**APPROVED
DRAINAGE PLAN**

SKETCH PLAT
STARKEY DEVELOPMENT CENTER

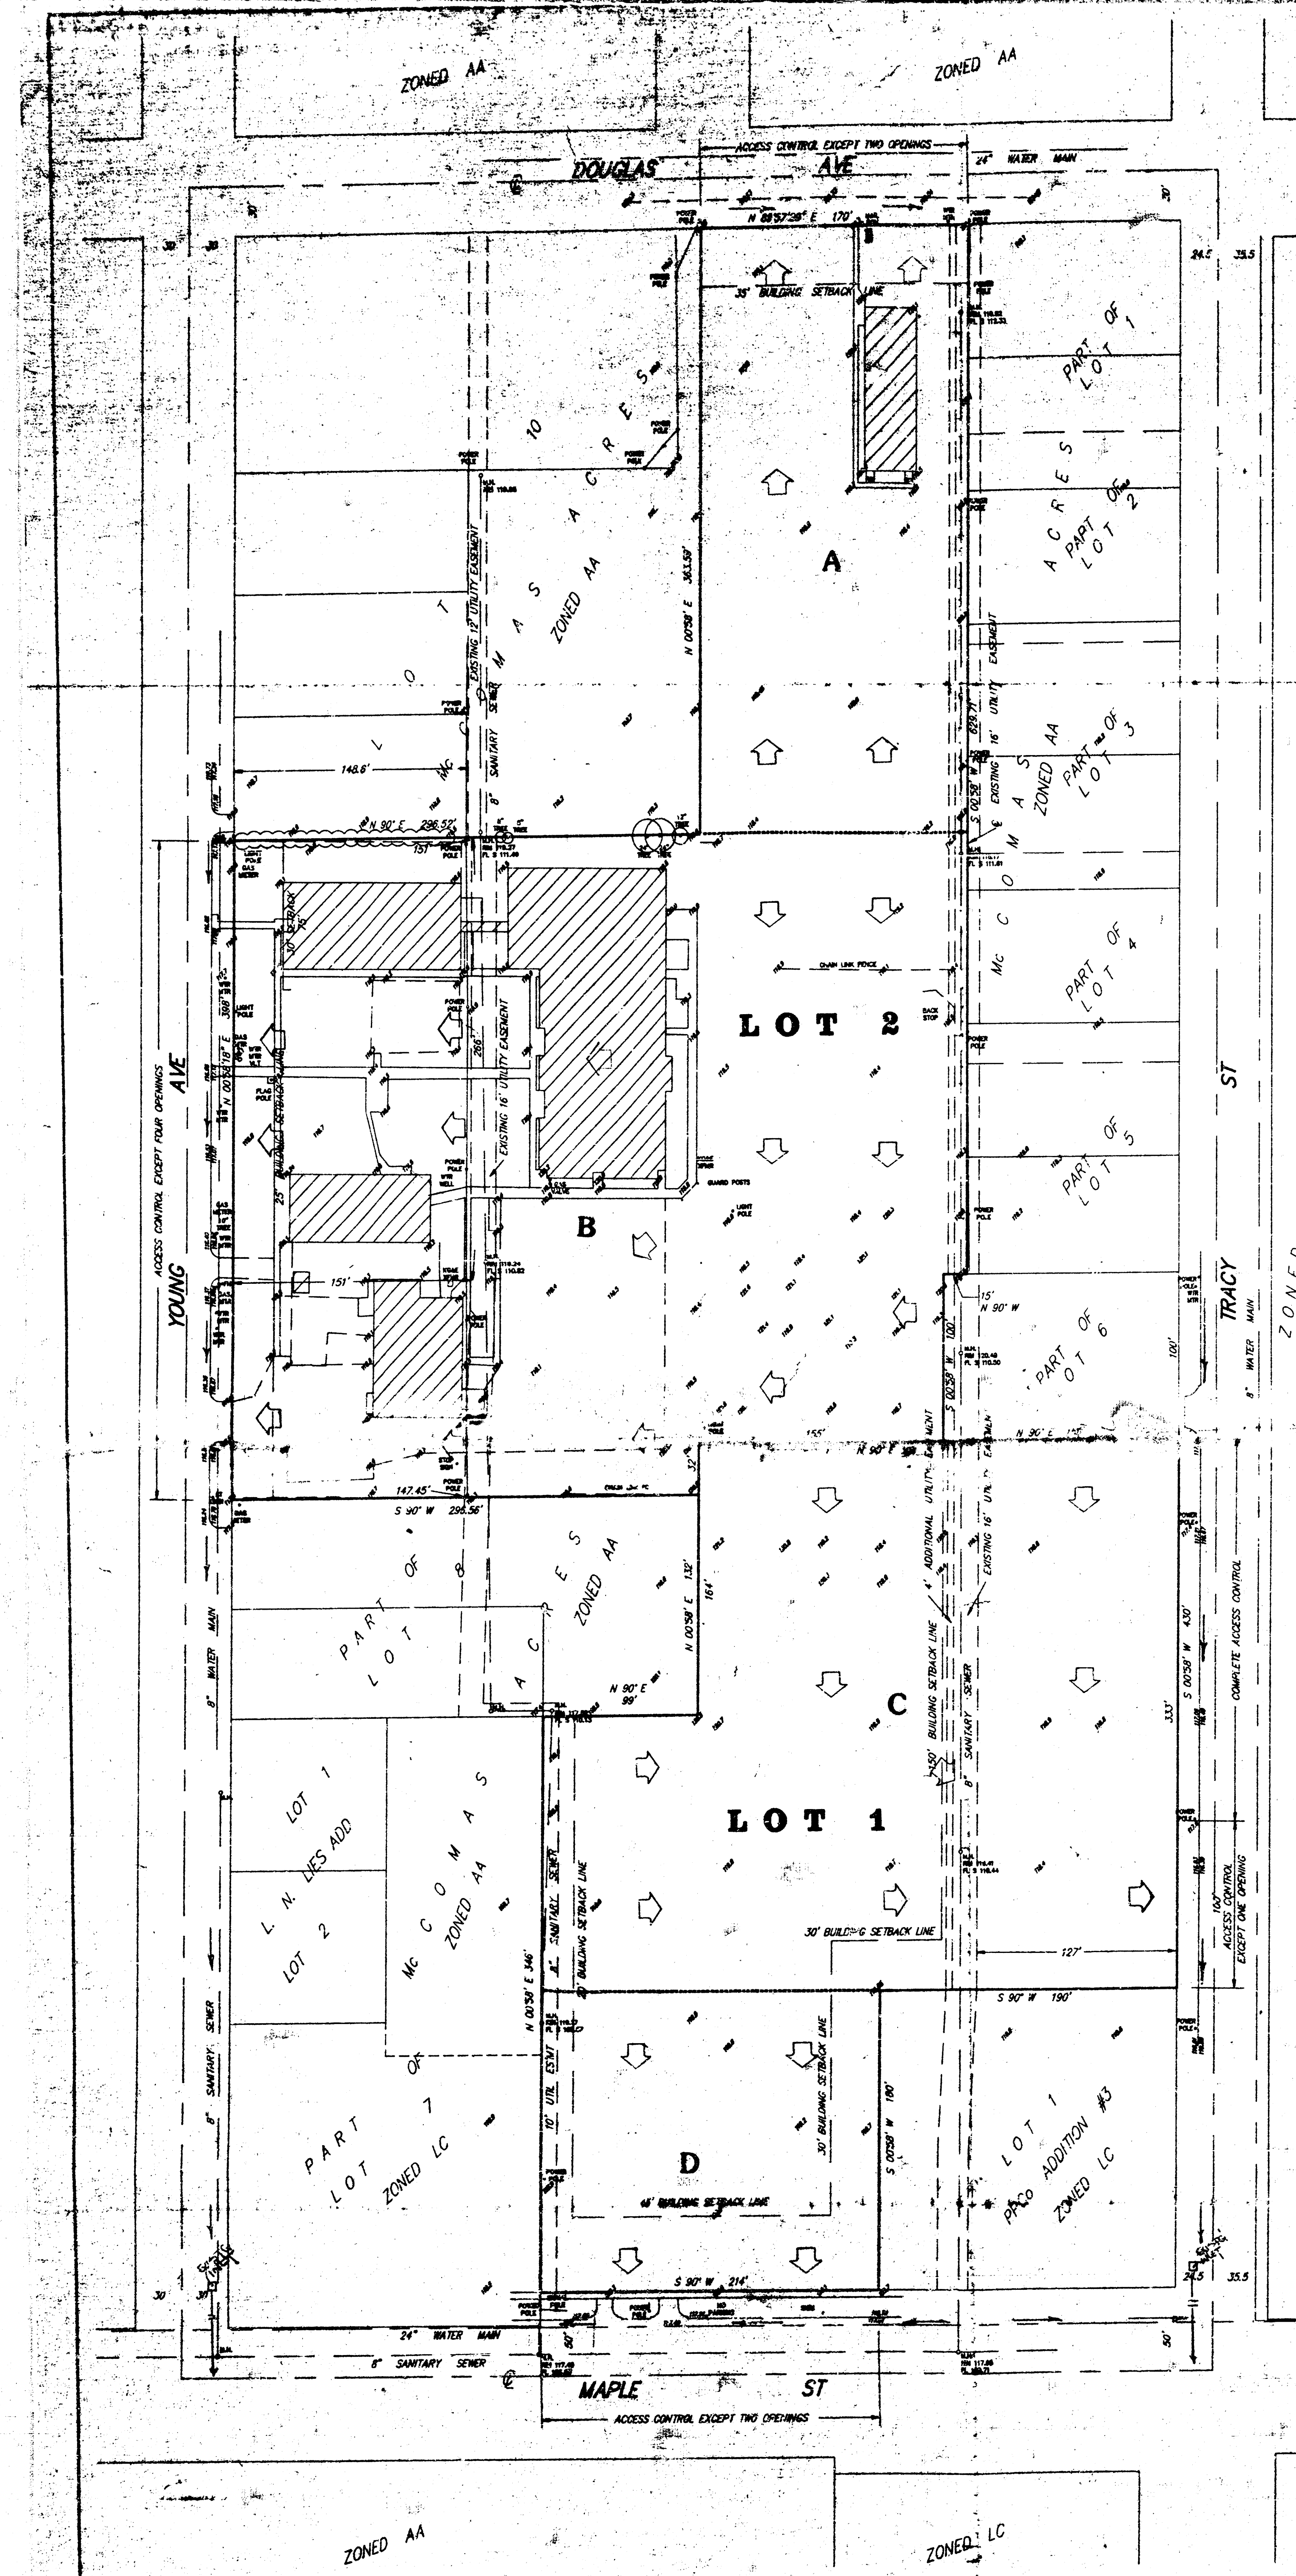
Area C shall be limited to the existing condition discharge runoff amount draining to Tracy St. The amount of allowable runoff to Tracy from Area C shall be 5 C.F.S. which is the 100 year storm discharge with a runoff factor of 0.25.

An alternative to the detaining runoff method is to extend storm sewer from Maple into the Area C side.
